Hillmead (6421 Bradley Blvd): Administrative Subdivision Plan No. 620200160

Completed: 7/19/2021

Administrative Subdivision Plan No. 620200160

Figure 3: Proposed Administrative Subdivision Lot Configuration.
 Green shading represents existing (offsite) and proposed (onsite) conservation easements

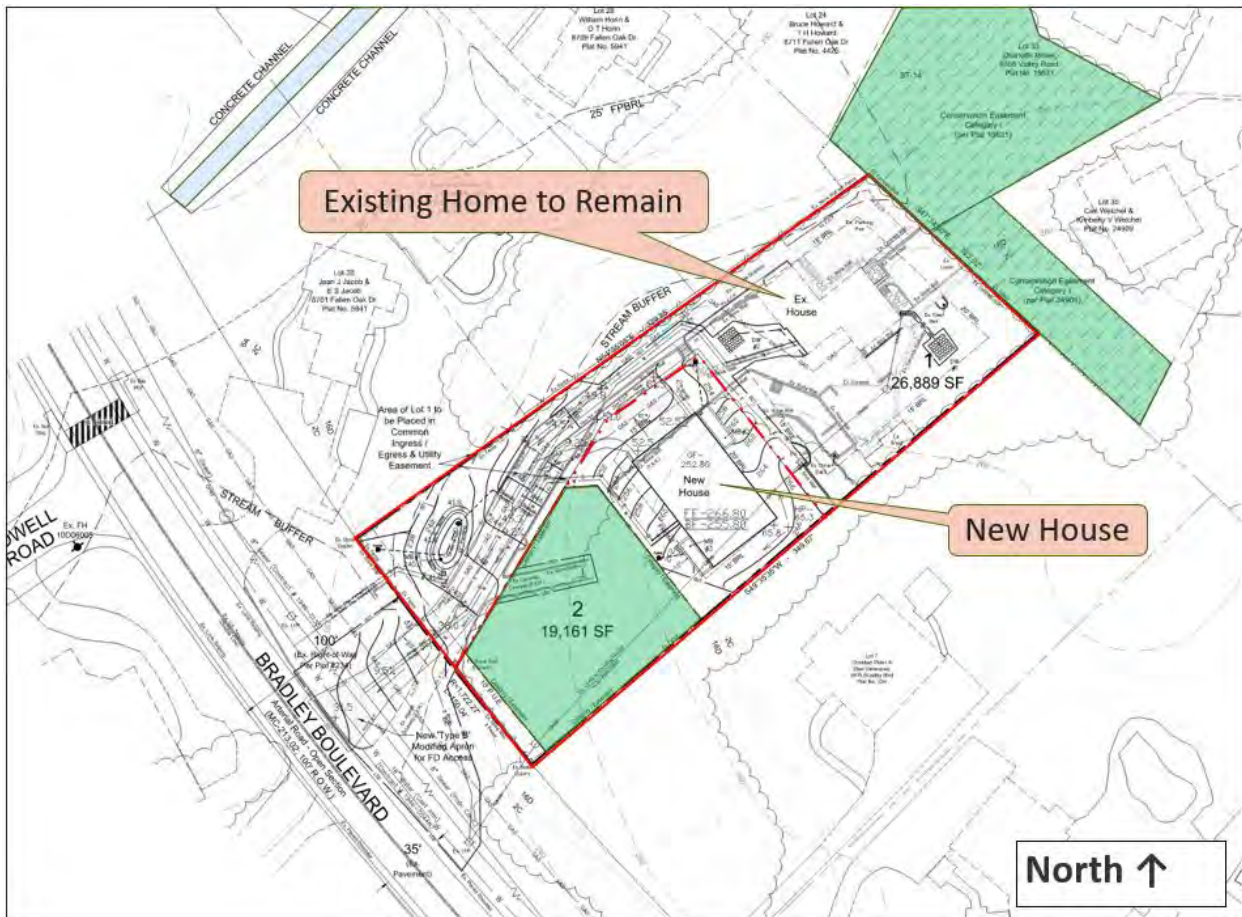
In Figure 3 (below) the proposed lot configuration demonstrates that the proposed lots can accommodate the two single-family detached dwellings as proposed in conformance with the development standards for the R-60 zone. Bradley Boulevard has a total of 100 feet of right-of-way dedicated along the lot frontage (Plat 234). Therefore, no further dedication is required as part of this Application. The recorded plat also includes an existing 10-foot Public Utility Easement (PUE) recorded along the Bradley Boulevard frontage within the Subject Property. As conditioned the Applicant will construct the master-planned sidepath along the Site frontage with the work extending to and connecting with a nearby bus stop and cross walk (beyond the Property frontage) at Howell Road. The Applicant will coordinate with MDOT SHA to finalize the design for the facilities as applicable. The development includes a new onsite Category II Conservation Easement which is proposed to protect substantial portions of the steep slopes, highly erodible soils and the associated tree cover, some of which are specimen in size. The proposed 0.21-acres of conservation easement setting will provide partial forest conservation credit and the remainder of the worksheet requirements will be addressed offsite either through credits purchased in an offsite bank or via a payment of fee-in-lieu, as conditioned by this report.

The lot design is in a flag/pipestem configuration which is similar layout as the existing adjacent lots towards northeast. Through the review process, the proposed conservation easement footprint was expanded, and the associated BRL has been modified accordingly to maintain at least 15 feet of separation between the BRL for the new home and the conservation easement. The resulting 133-foot modified front BRL is considerably more restrictive than the established building line (EBL) of 90 feet and will generate a building envelop for the new home that would be similar in character for other homes in the R-60 zone. The R-60 zone requires a minimum 8-foot and 18-foot combined side setback, and the Applicant proposes 15-foot side setbacks for both lots. The proposed lots meet the minimum development standards for the R-60 zone in terms of size, street frontage, and setbacks, and meet the infill development standards for lot coverage.

Figure 4: Variance Exhibit – Shaded areas shown include updated tree impacts

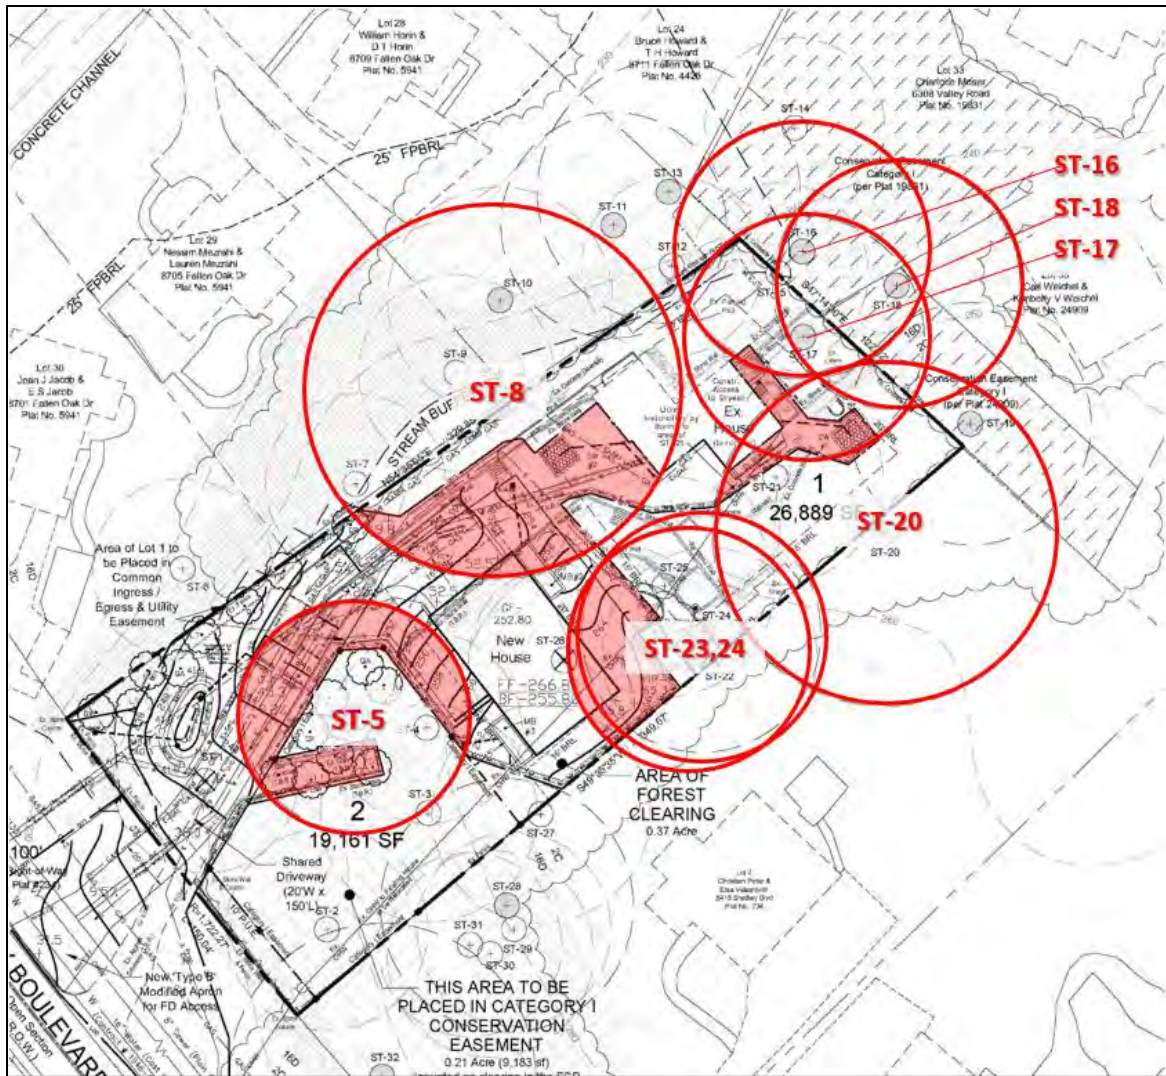
The Applicant proposes to impact eight (8) subject trees that are considered high priority for retention under Section 22A-12(b)(3) of the County Forest Conservation Law. Therefore, a variance request is required with this Application. As discussed in greater detail in the Technical Review Section 4.3 (further below) no subject trees are proposed for removal and Staff recommends approval of the variance request for the trees to be impacted but retained.

Variance Request - The Applicant submitted a variance request in a letter dated July 2, 2021, for the impacts of subject trees (Attachment C). The Applicant proposes to impact eight (8) subject trees that are considered high priority for retention under Section 22A-12(b)(3) of the County Forest Conservation Law. Details of the variance trees are shown graphically in Figure 4 and listed in Table 3 below. Staff notes that although the numerical CRZ disturbance related to Tree 5 is apparently high, due to site conditions which have limited growth root (such as the existing driveway, retaining walls and the associated grade separation) and the proposed use of specialized construction techniques to carefully demolish and naturalize the driveway spur nearest to the tree, the actual disturbance to tree is effectually lower than the numerical figures would suggest. Further, as shown in Figure 4, the construction impacts to ST-5 (aside from the careful demolition of the driveway spur) are generally proposed to occur on the fringes of the CRZ rather than in closer proximity to its trunk. Additionally, tree protection work is conditioned to occur under the direction of an ISA Certified Arborist who is also a MD Licensed Tree Care Expert (MD LTE) and in coordination with the M-NCPPC Forest Conservation Inspector; the disturbance will be limited to the minimum practical extent.

DETAIL VIEW: FUTURE SIDEWALK
SCALE 1" = 30'

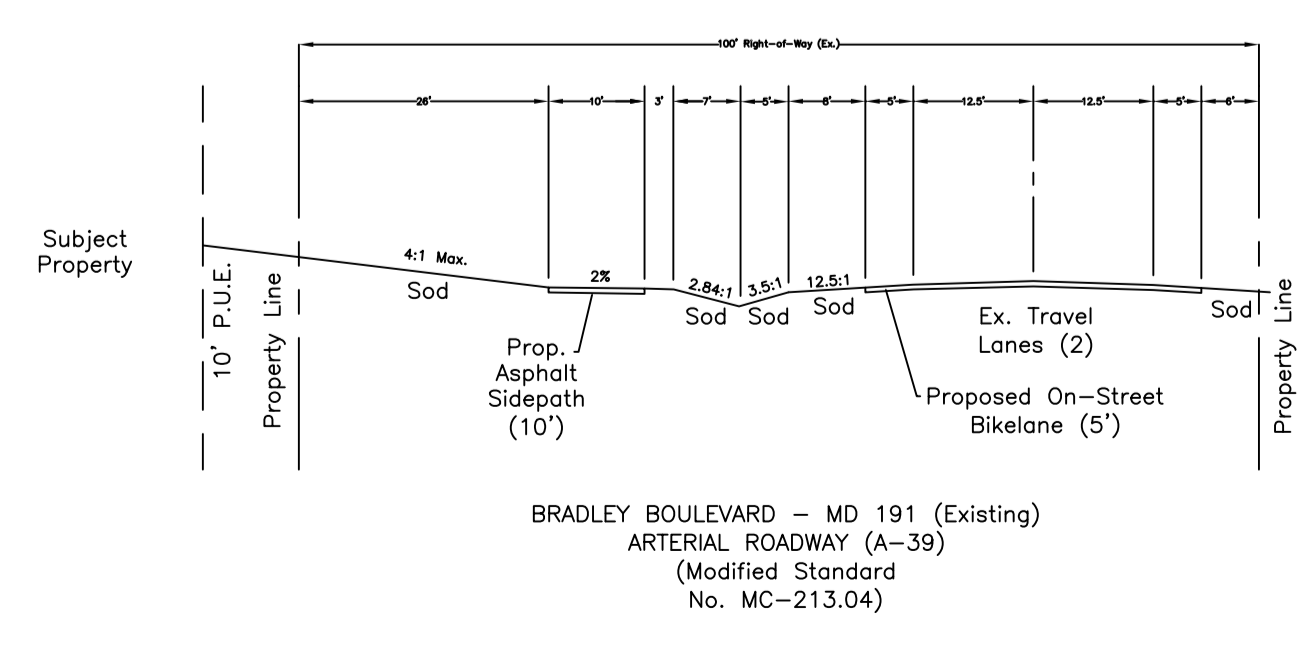
7. Prior to Certification of the Administrative Subdivision Plan, the Applicant must revise the Administrative Subdivision Plan to include a cross-section of Bradley Boulevard showing the sidepath on the north side of Bradley Boulevard along the Property’s frontage.
